SUBJECT: Calvert Cliffs Nuclear Power Plant
Unit Nos. 1 & 2; Docket Nos. 50-317 & 50-318
Response to Request for Additional Information Regarding Interim Inspection
Requirements for Reactor Pressure Vessel Head (TAC NOS. MB7752 and
MB7753)

RESPONSE TO NRC REQUEST FOR ADDITIONAL INFORMATION

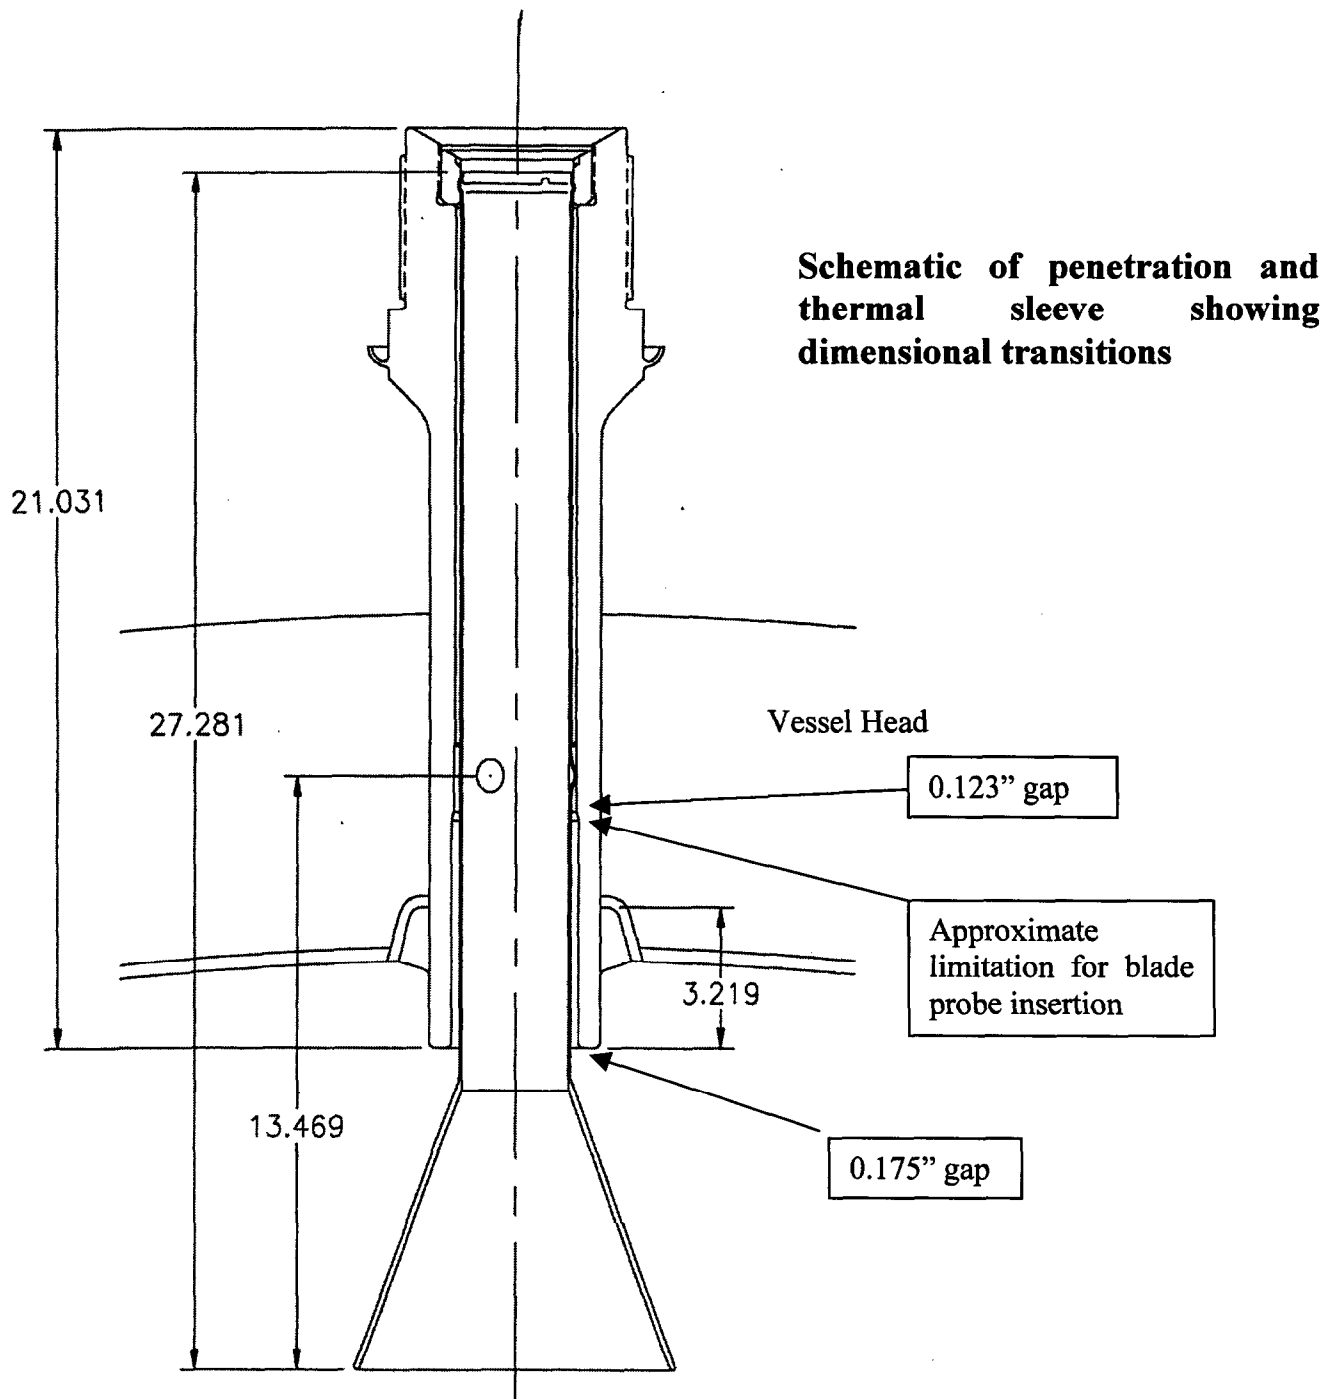
What is the justification that coverage up to 0.75 inches above the weld will provide an adequate level of quality and safety? In other words, provide justification that increasing the scope of inspection to 2 inches above the J-groove will not provide an increase in quality and safety. Are there residual stress data that indicates that 0.75 inches is a sufficient level above the weld, or is there any other basis that demonstrates an acceptable level of quality and safety for the restricted inspections?

Primary water stress corrosion cracking in RPV heads is caused by susceptible materials under high residual stresses usually caused by mechanical working and/or shrinkage stresses associated with welding. A diagram of the Calvert Cliffs RPV head configuration is presented in Figure 1. A Finite Element Analysis was used to calculate the distribution of residual stresses in the Calvert Cliffs RPV head nozzles (Reference 2). Representative results are provided in Figures 2 through 7, with the proposed 0.75-inch minimum coverage superimposed. The residual hoop stress declines along a steep gradient above the weld. Within the first 0.75 inches above the weld, the maximum residual (plus operating) hoop stress decreases to below approximately 40 ksi in all cases. Therefore, the residual plus operating stress existing 0.75 inches above the J-groove weld is less than, or equal to, the minimum stress that would make crack initiation possible. Both crack growth rate and time-to-initiation have been shown to be strongly dependent on applied stress, with damage rate proportional to σ^m , where m ranges between 4 and 5.5 (References 3 and 4). This correlation indicates that a 50% reduction in stress will result in a 16-fold reduction in damage rate (or a 16-fold increase in PWSCC initiation time.) Both a threshold stress, or stress-based, time-to initiation model indicate a very low likelihood of the initiation of cracks above 0.75 inches above the top of the uphill side of the nozzle penetration.
